Product Change Notice

- Products : Samsung 2835 LED series
- Change : Addition of manufacturing site
- Remark : Effective from December, 2021

Summary

2-1. Electrical Performance

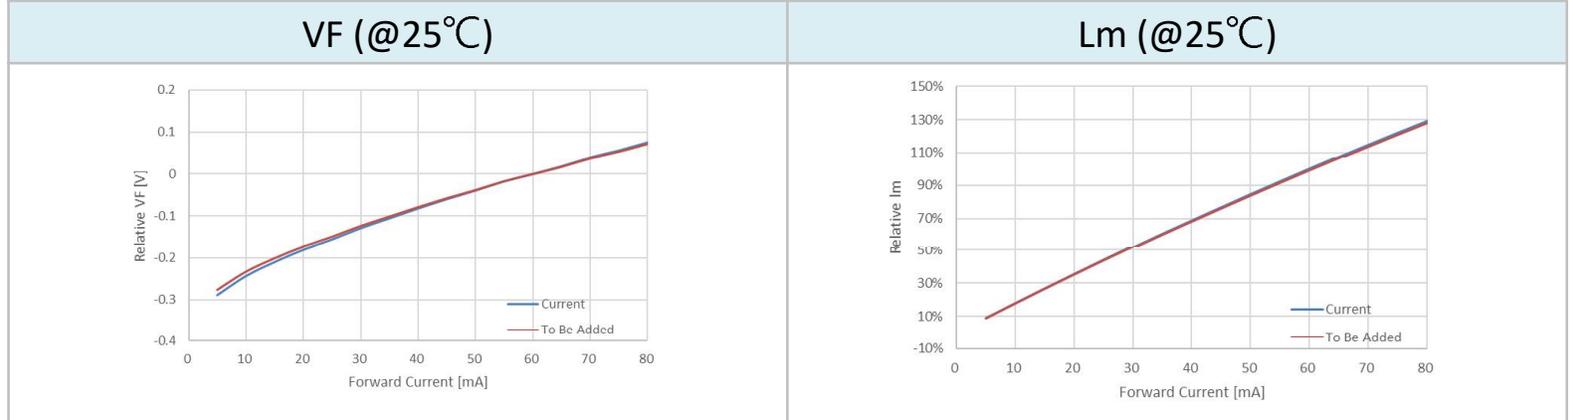
● Substantially same electrical characteristics verified with 281BA+ (3V)

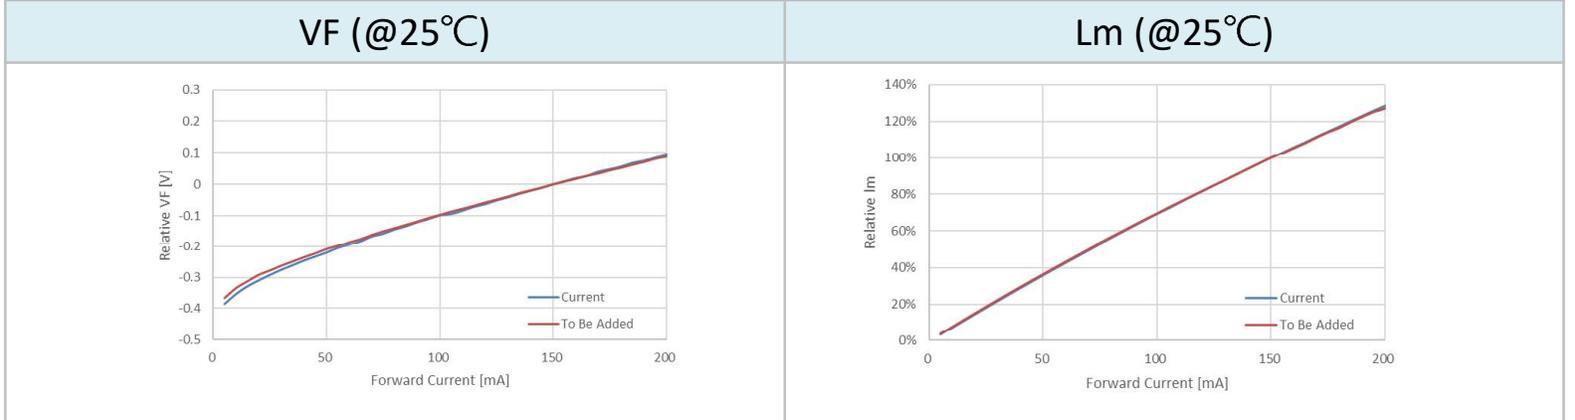
● Substantially same electrical characteristics verified with 281B+ (3V)

2-2. Electrical Performance

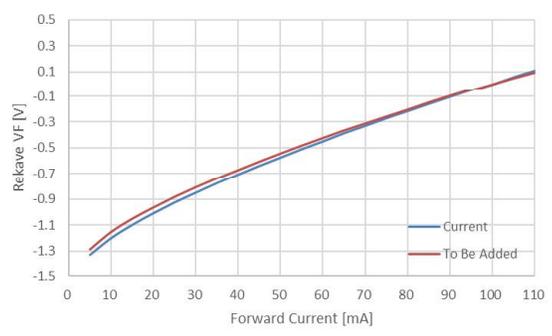
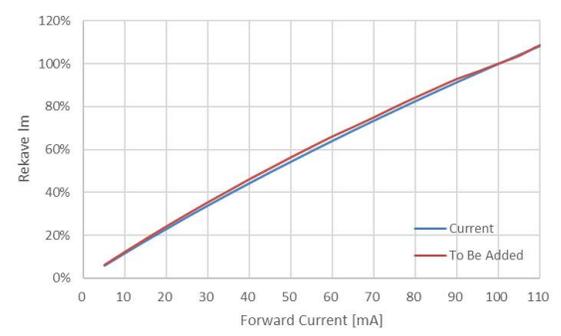
- Substantially same electrical characteristics verified with 283B+ (9V)

3-1. Thermal Performance

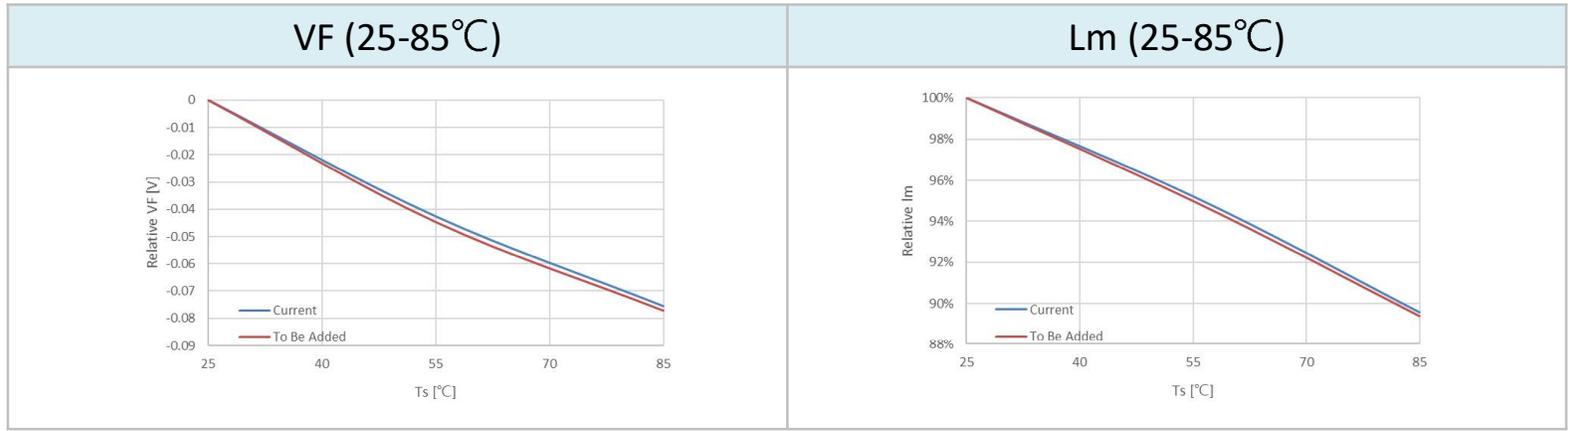
● Substantially same thermal characteristics verified with 281BA+ (3V)

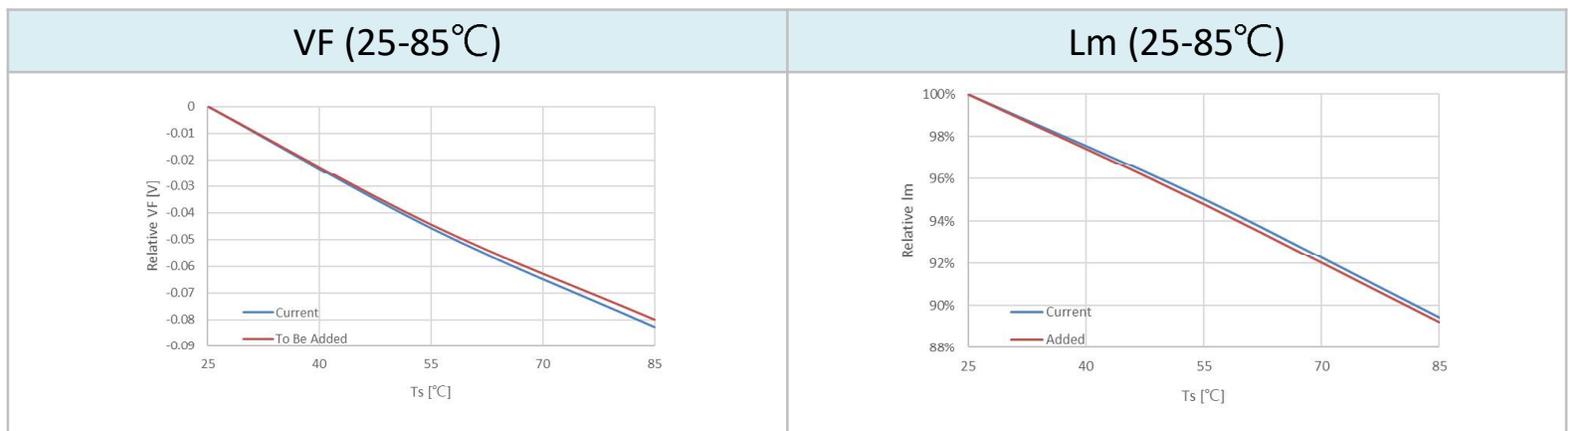
● Substantially same thermal characteristics verified with 281B+ (3V)

3-2. Thermal Performance

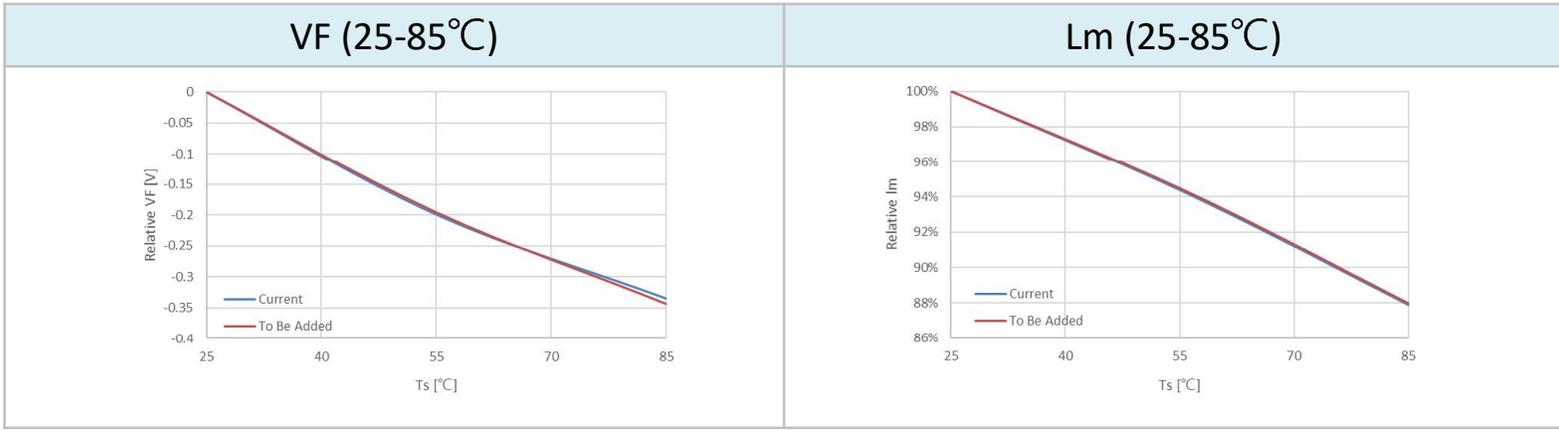
- Substantially same thermal characteristics verified with 283B+ (9V)

4-1. Radiation diagram

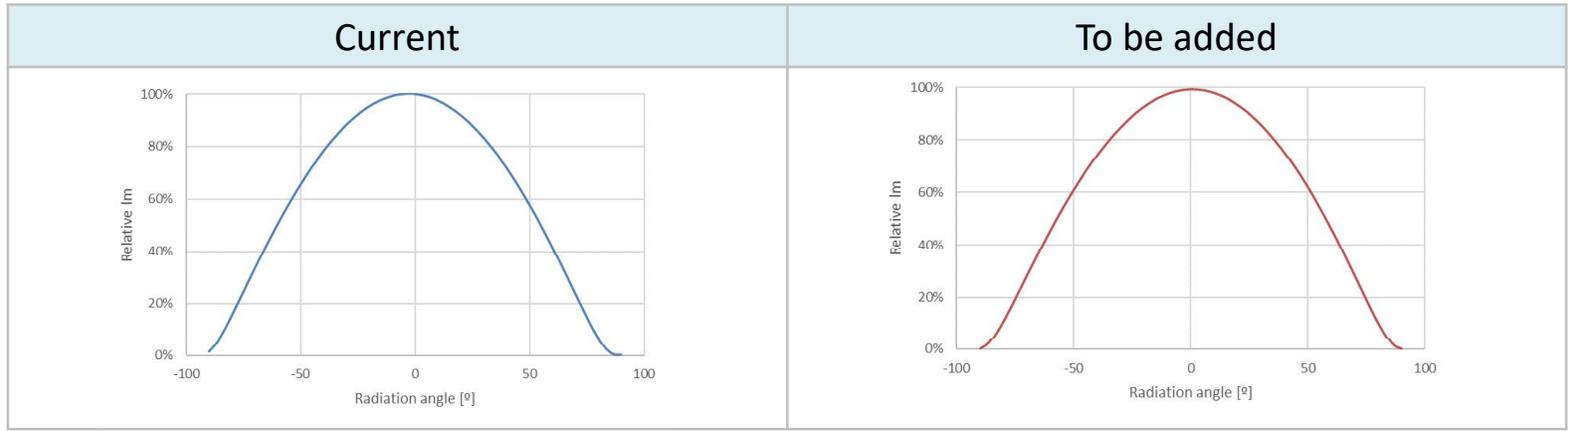
- Substantially same radiation diagram with 281BA+ (3V)

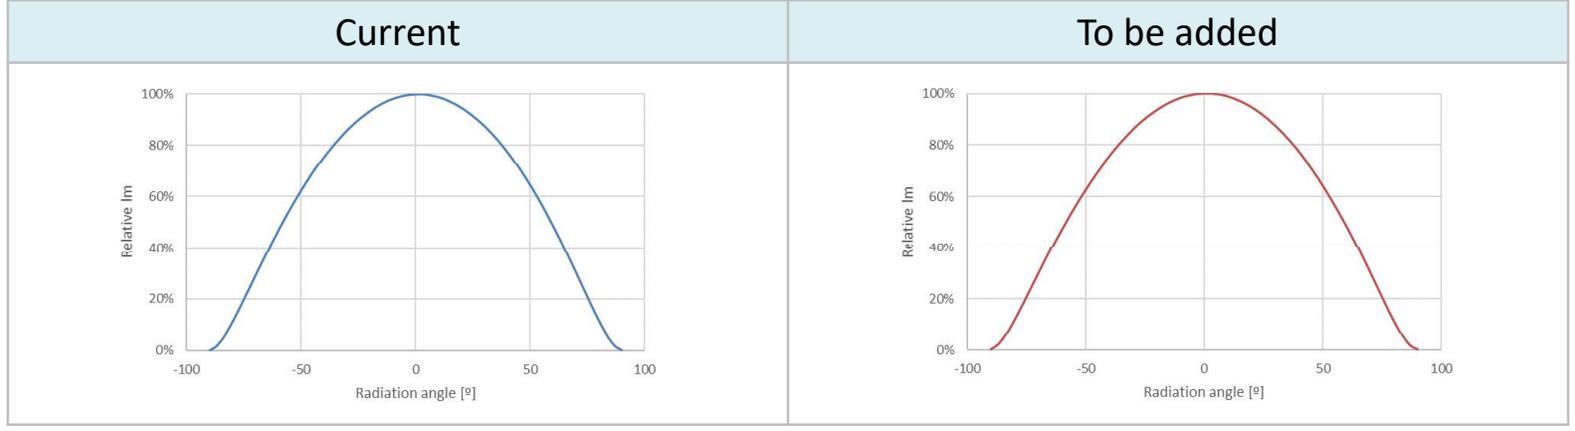
- Substantially same radiation diagram with 281B+ (3V)

4-2. Radiation diagram

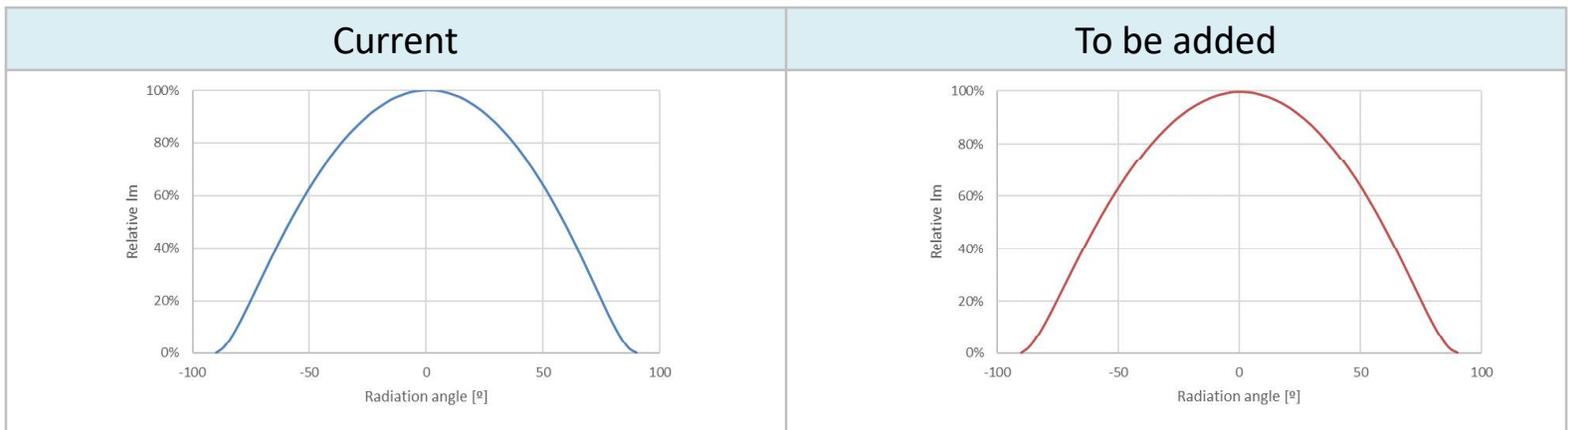
- Substantially same radiation diagram with 283B+ (9V)

5-1. Spectrum

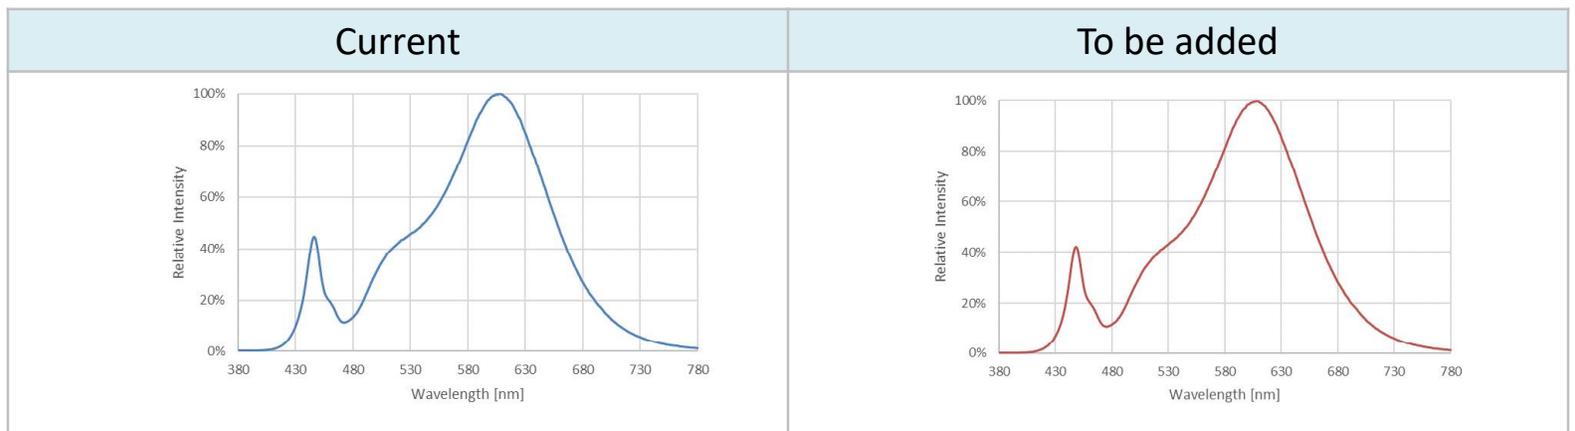
● Substantially same spectrum verified with 281BA+ (3V)

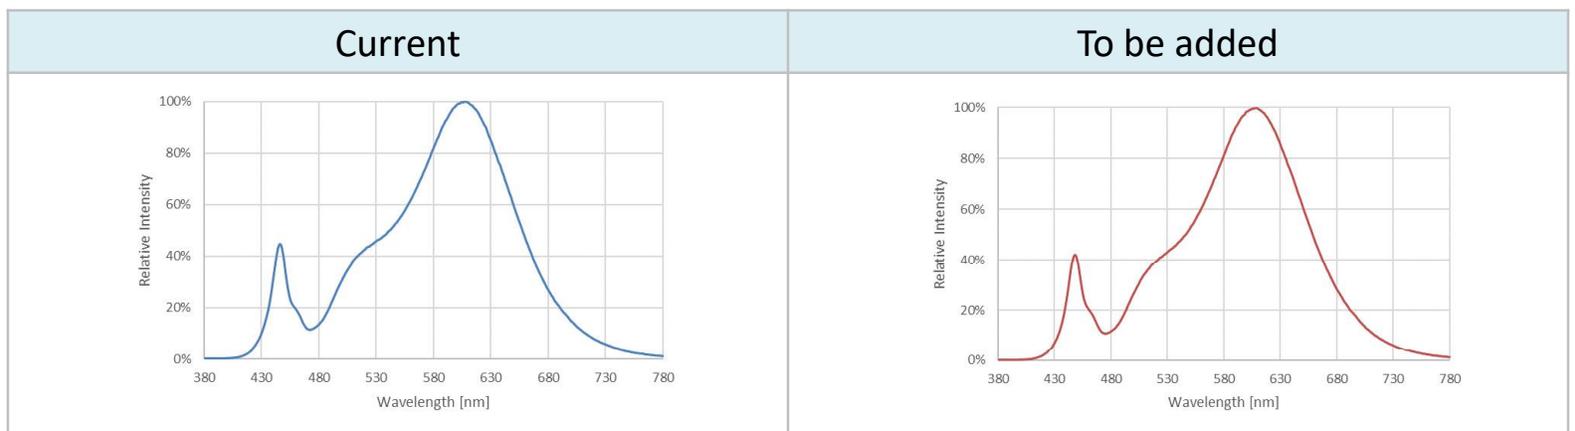
● Substantially same spectrum verified with 281B+ (3V)

5-2. Spectrum

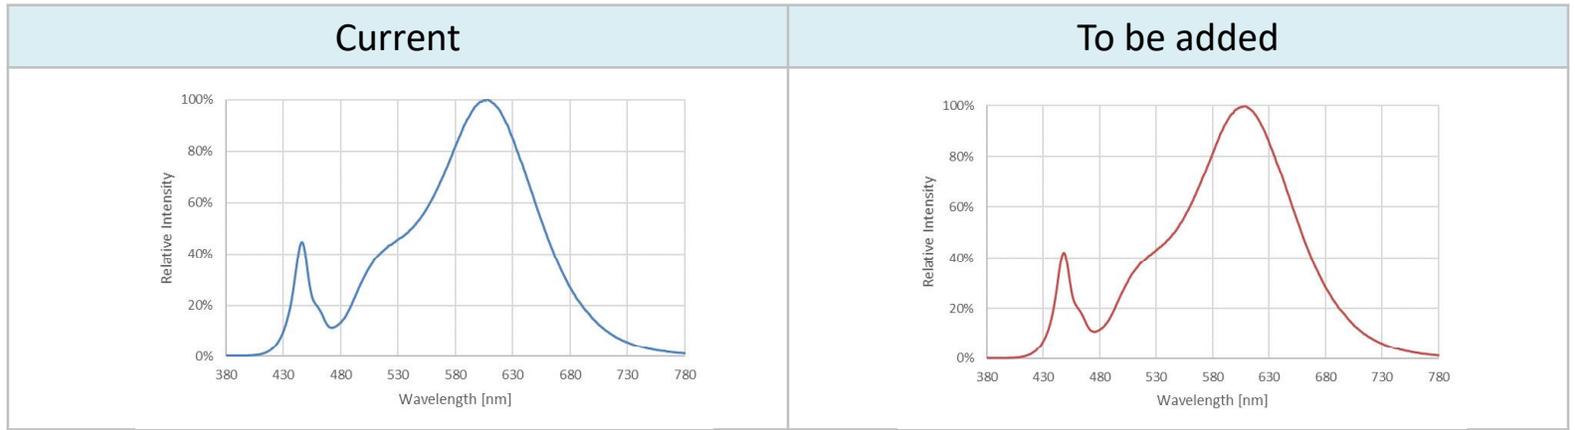
- Substantially same spectrum verified with 283B+ (9V)

6-1-2. Reliability for 281BA+

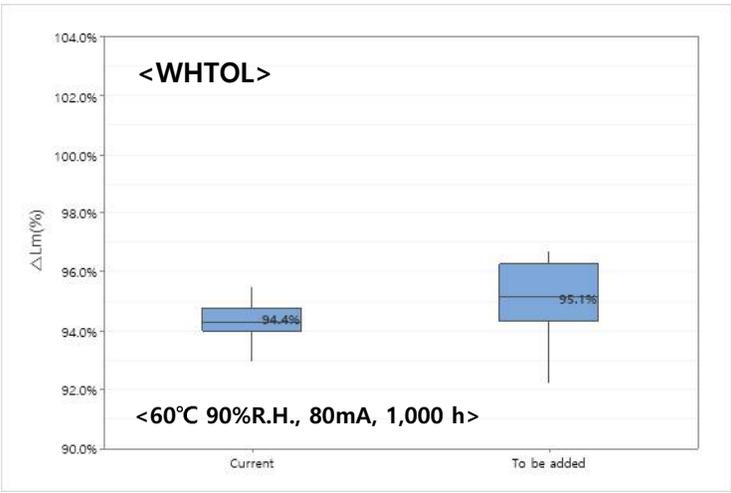
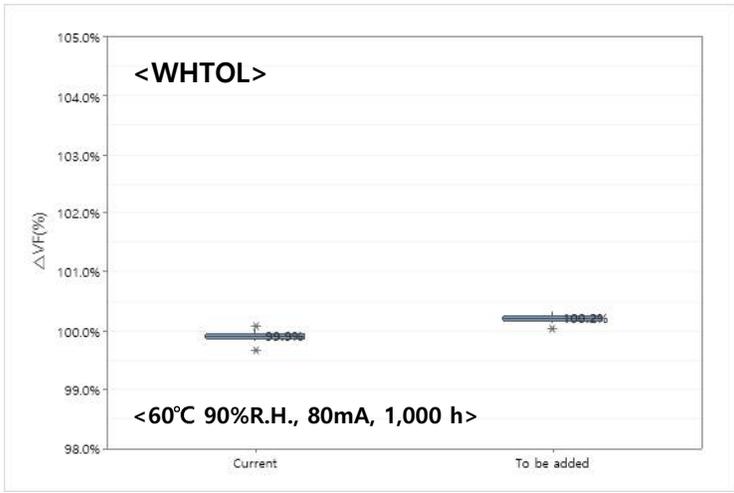
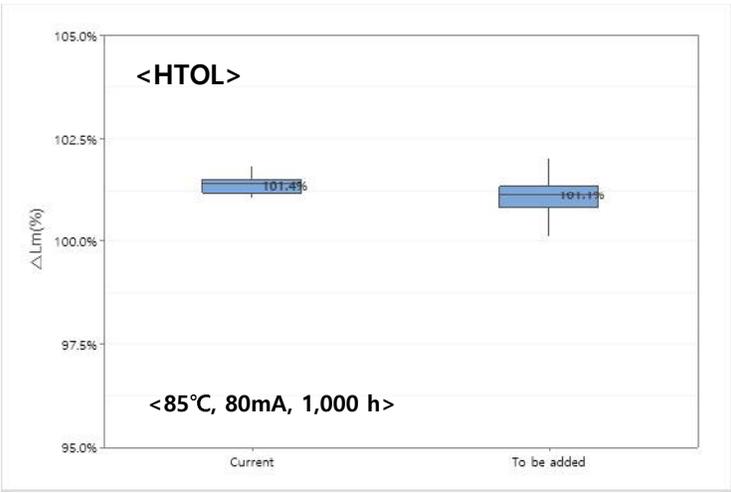
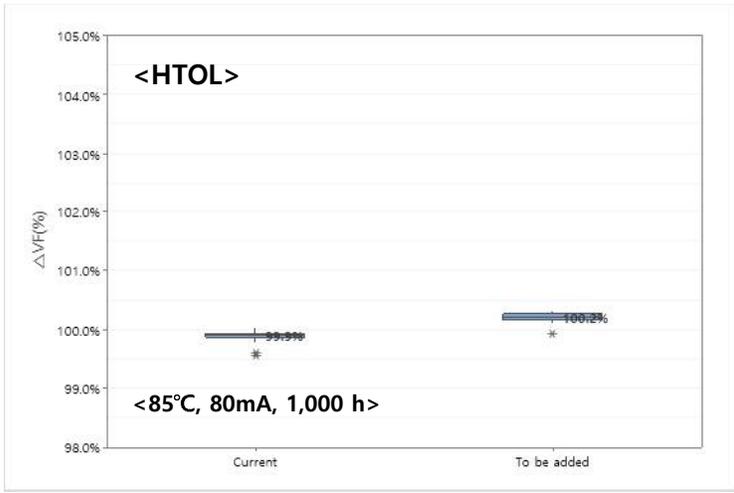
● Passed all criteria in the specifications

6-2-2. Reliability for 281B+

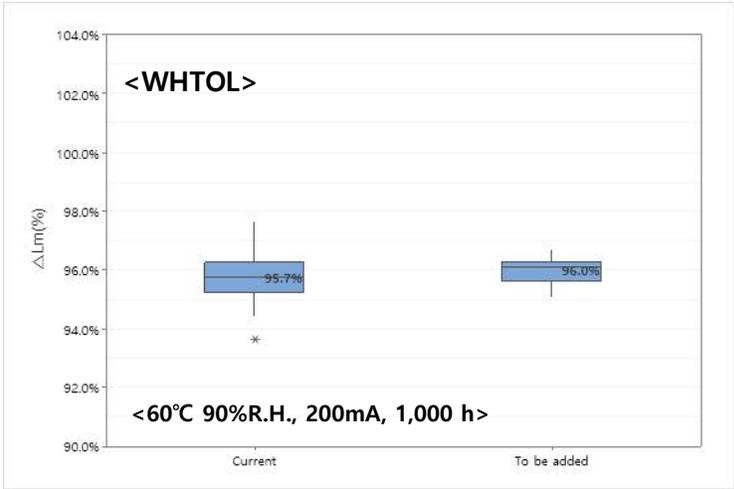
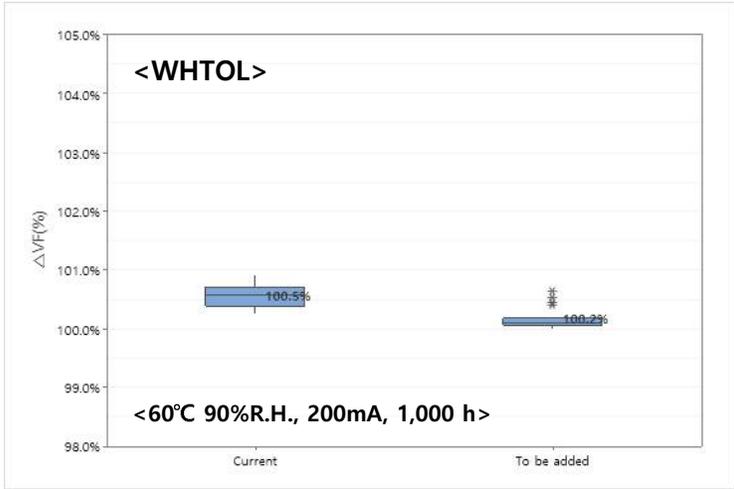
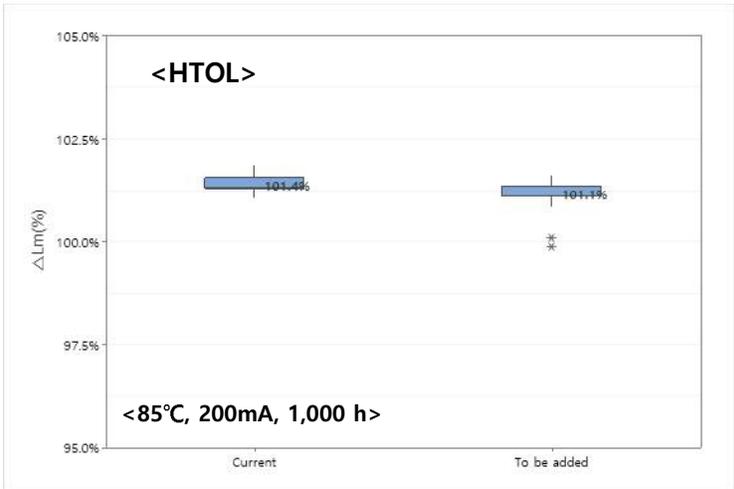
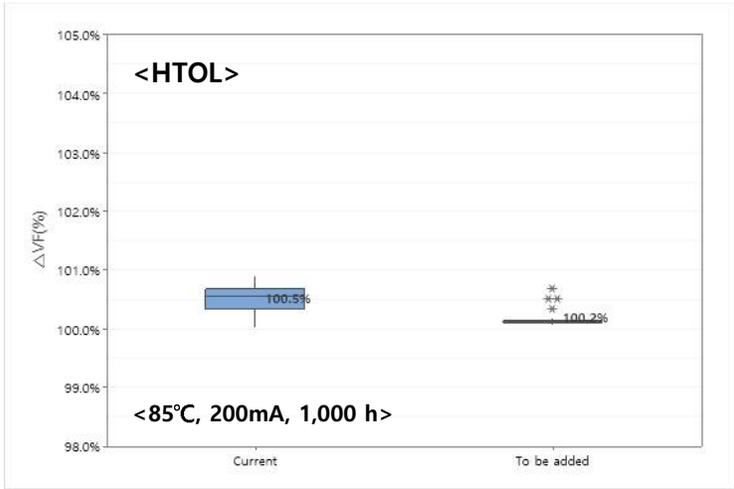
- Passed all criteria in the specifications
